From the Vancouver Fraser Port Authority re: Requirements for Information Pertaining to Changes to the Roberts Bank Terminal 2 Project

ROBERTS BANK TERMINAL 2 PROJECT

Project Construction Update

ROBERTS BANK TERMINAL 2	
	ANTICIPATED PROJECT CONSTRUCTION SCHEDULE INCLUDING KEY CONSTRUCTION ACTIVITIES	
	DATE: 06/06/2018	FIG No. 4-9

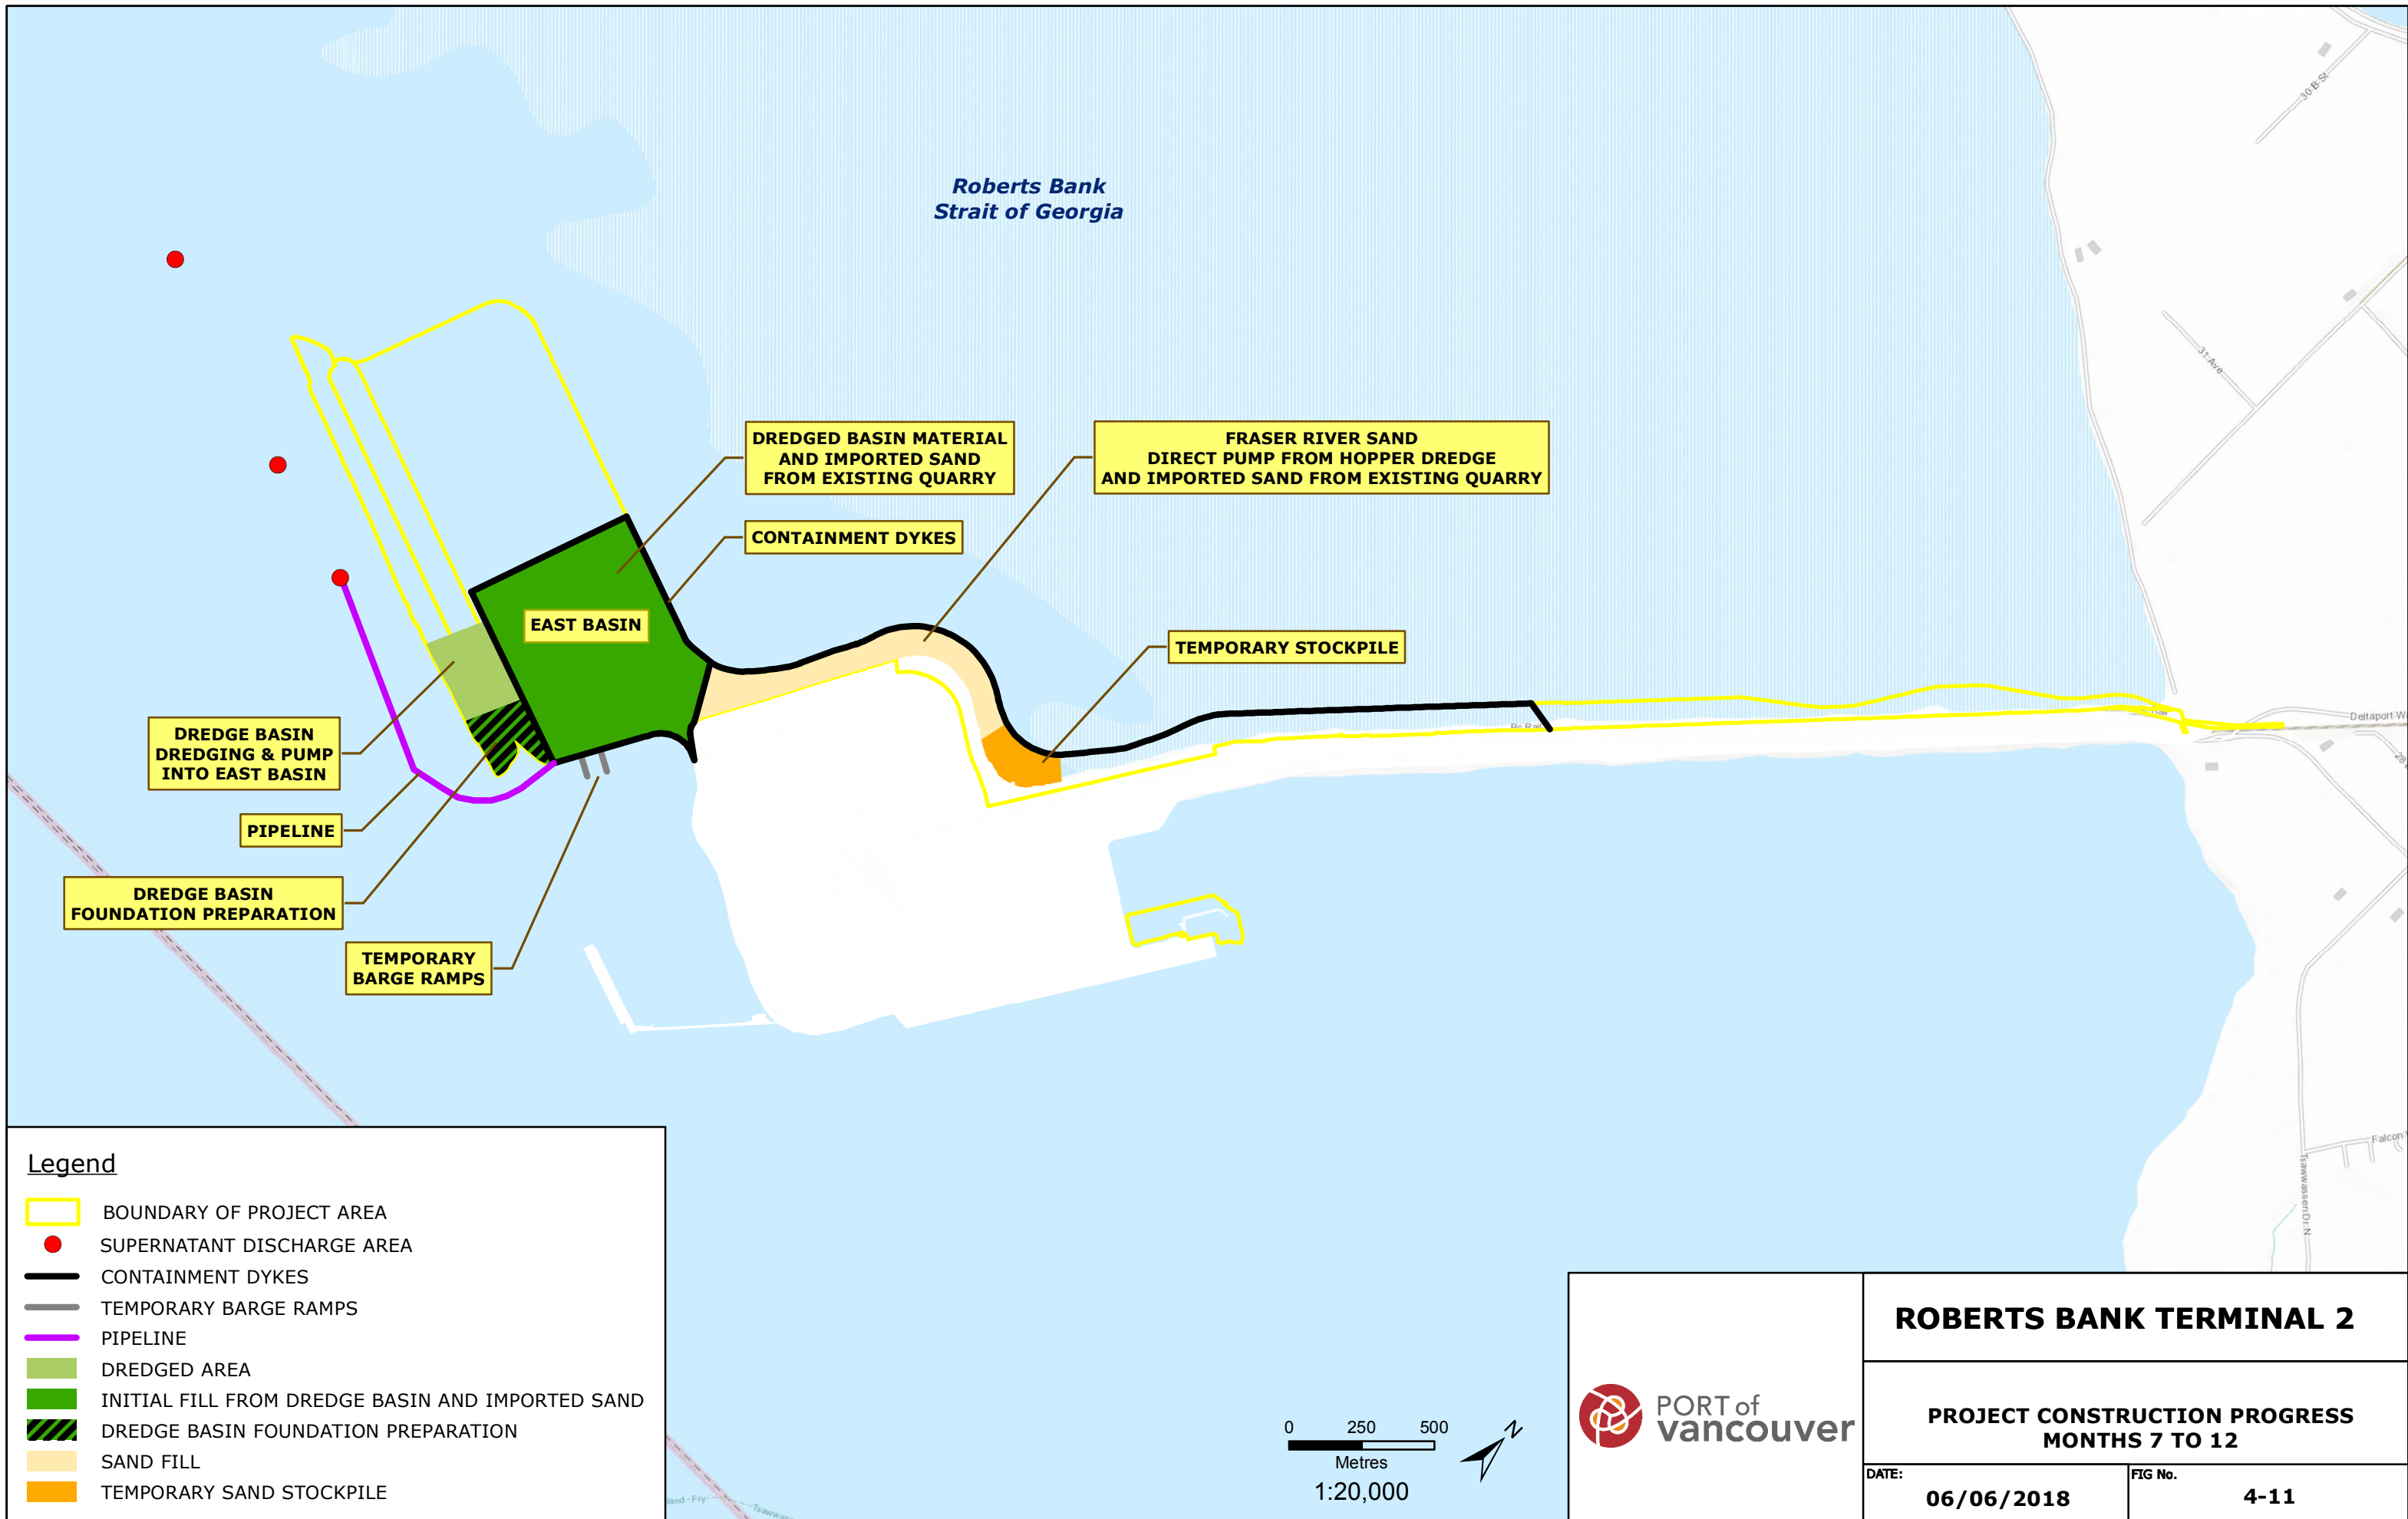
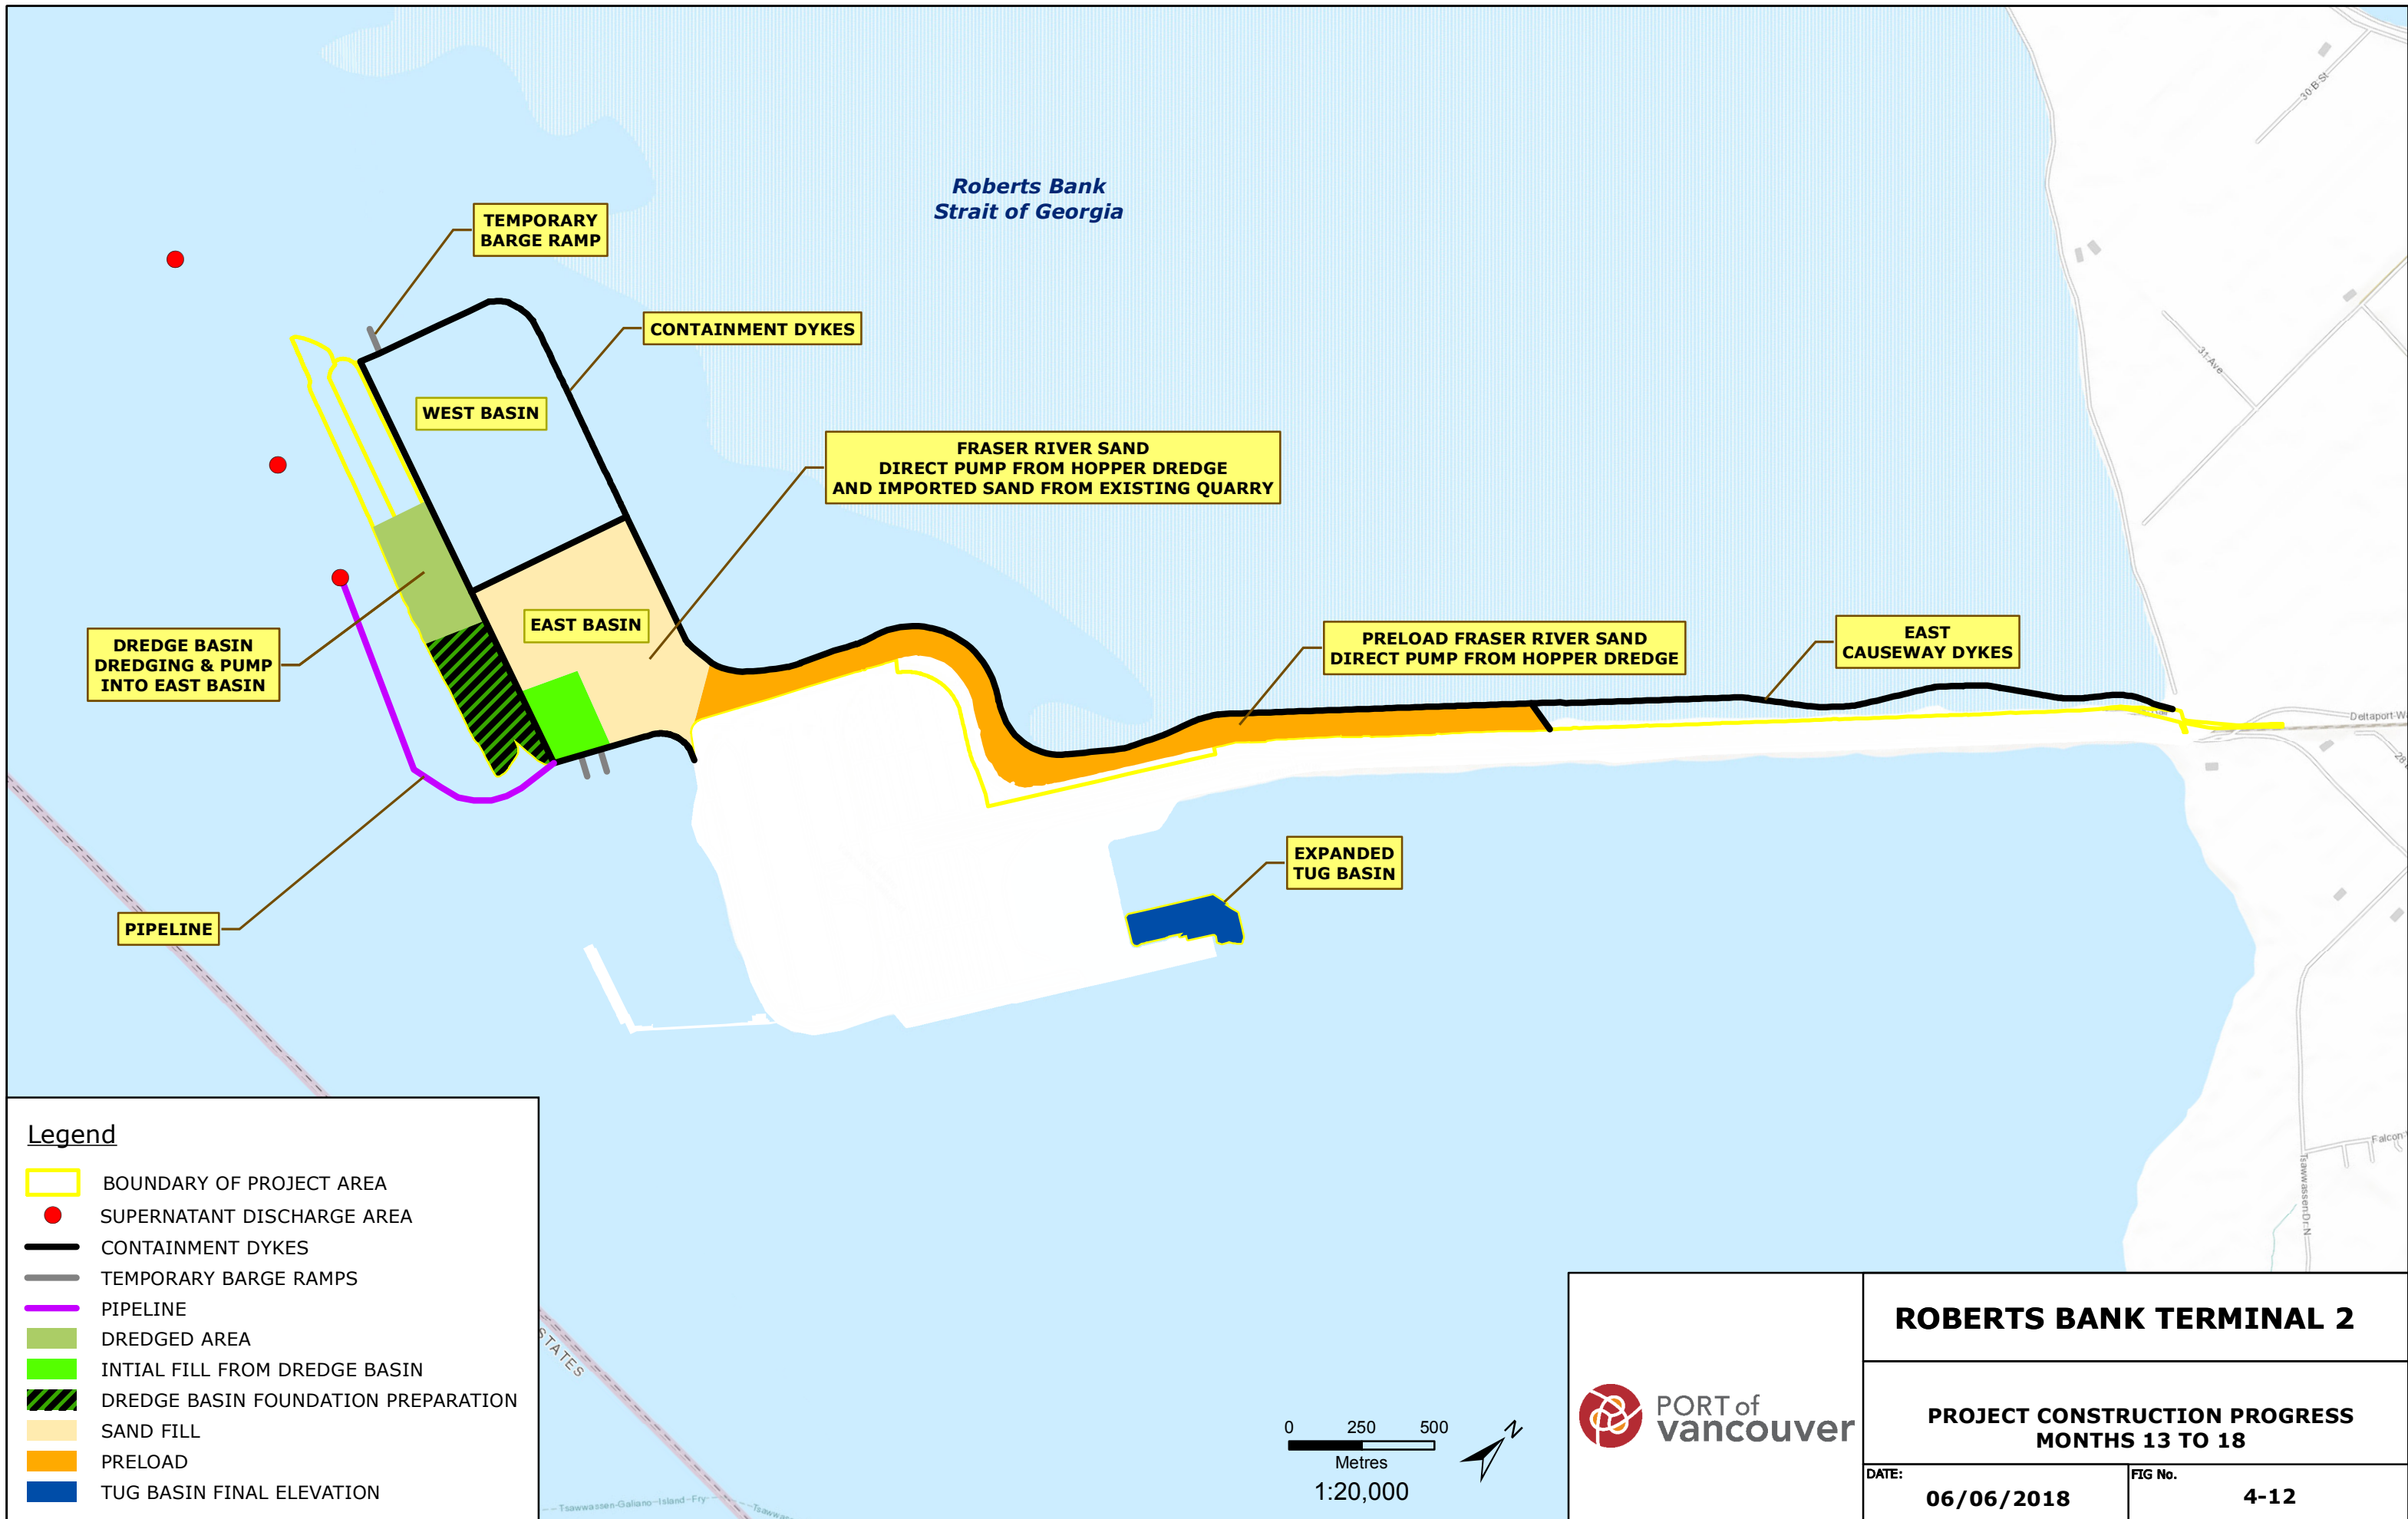
Since completion of the preliminary construction schedule (as shown in EIS Figure 4-9 and described in detail in EIS Appendix 4-E), FRPD acquired a newer TSHD with pump-ashore capability, the *FRPD309*, as outlined in EIS Section 4.4.1.8 and IR1-11 of CEAR Document #897. Since it was acquired, the *FRPD309* has been performing the annual maintenance dredging of the Fraser River and pumping ashore, as required. With its proven capability, the VFPA has revised the Project construction sequence to incorporate the discharge of Fraser River sand directly into fill areas⁶, eliminating the need for storage in the ITP. It should be noted that other dredge equipment with equivalent proven capability as the *FRPD309* could also perform this work at RBT2.

In **Attachment A**, Updated Figure 4-9 shows the timing of key construction activities based on the updates described herein, while Updated Figures 4-10 to 4-18 illustrate the progress of construction activities in 6-month durations, and Updated Figures 4-19 and 4-20 show progress in 9-month durations.

- Appendix E Section 2.3 Emission Sources (EIS Appendix 9.2-A) – the main activities projected to occur during the updated peak construction scenario (month 39) are shown in the preliminary construction schedule illustrated in Updated Figure 4-9 in **Attachment A** and detailed in **Attachment B2**; and

ROBERTS BANK TERMINAL 2	
	TERMINAL 2 OVERPASS WEST STRUCTURE CONCEPTUAL LAYOUT	
DATE:	06/06/2018	FIG No.
		4-32

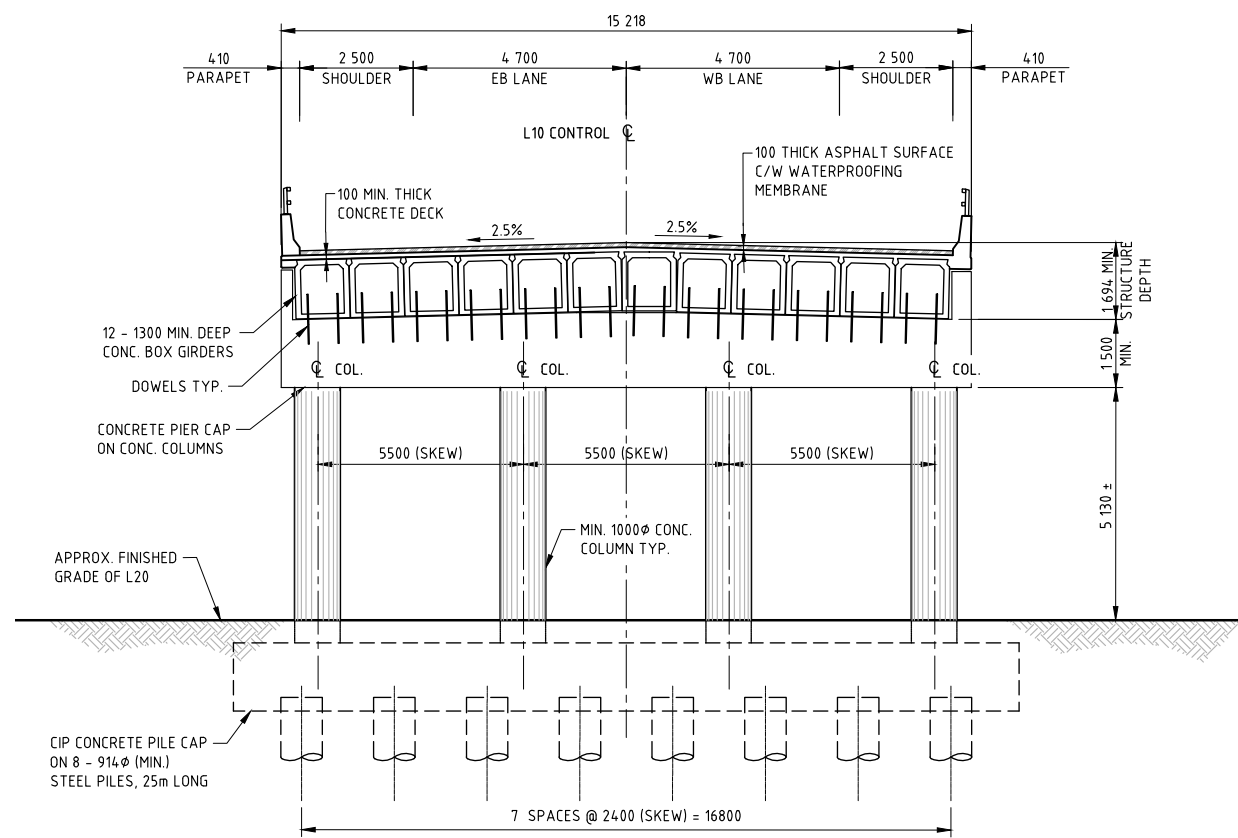
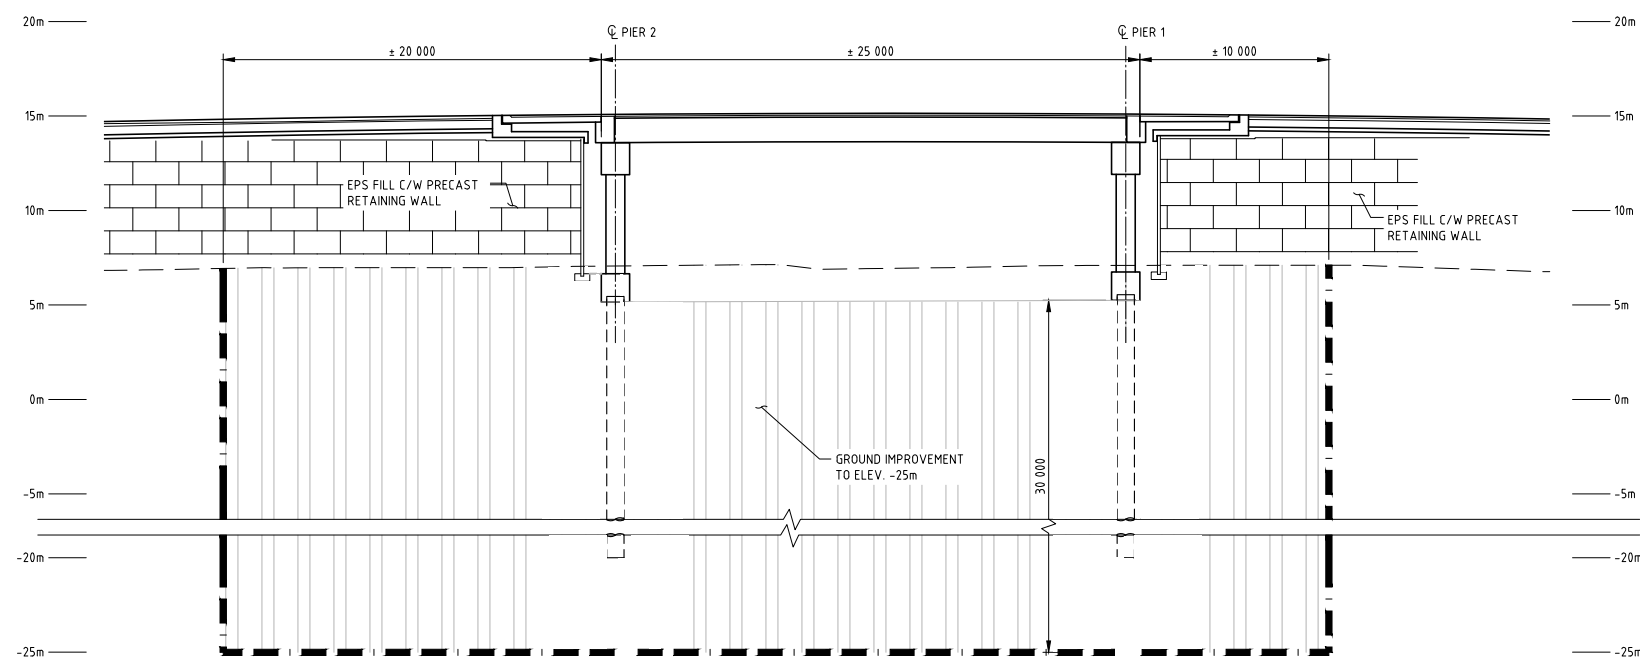
For the overpass, the conceptual design was further advanced incorporating the latest version of the bridge code, CAN/CSA-S6-14, as shown in **Attachment A**, New Figure 4-32 and **Attachment A**, New Figure 4-33. **Attachment A**, Updated Figure 4-7 shows the updated overpass and road connection. Land-based vibro-replacement densification of native and reclaimed soils will be carried out around the piled area and beyond the footprints of the overpass structures. The overpass will be founded on approximately 86 steel pipe piles driven from land to El.-20 m CD. Pile installation may require both a vibrator and a hammer (vibratory for the initial depths and hammer for the final set and blow count testing). Depending on the construction methodology applied, the overall pile installation duration will vary and may take up to 60 days, during daylight hours.
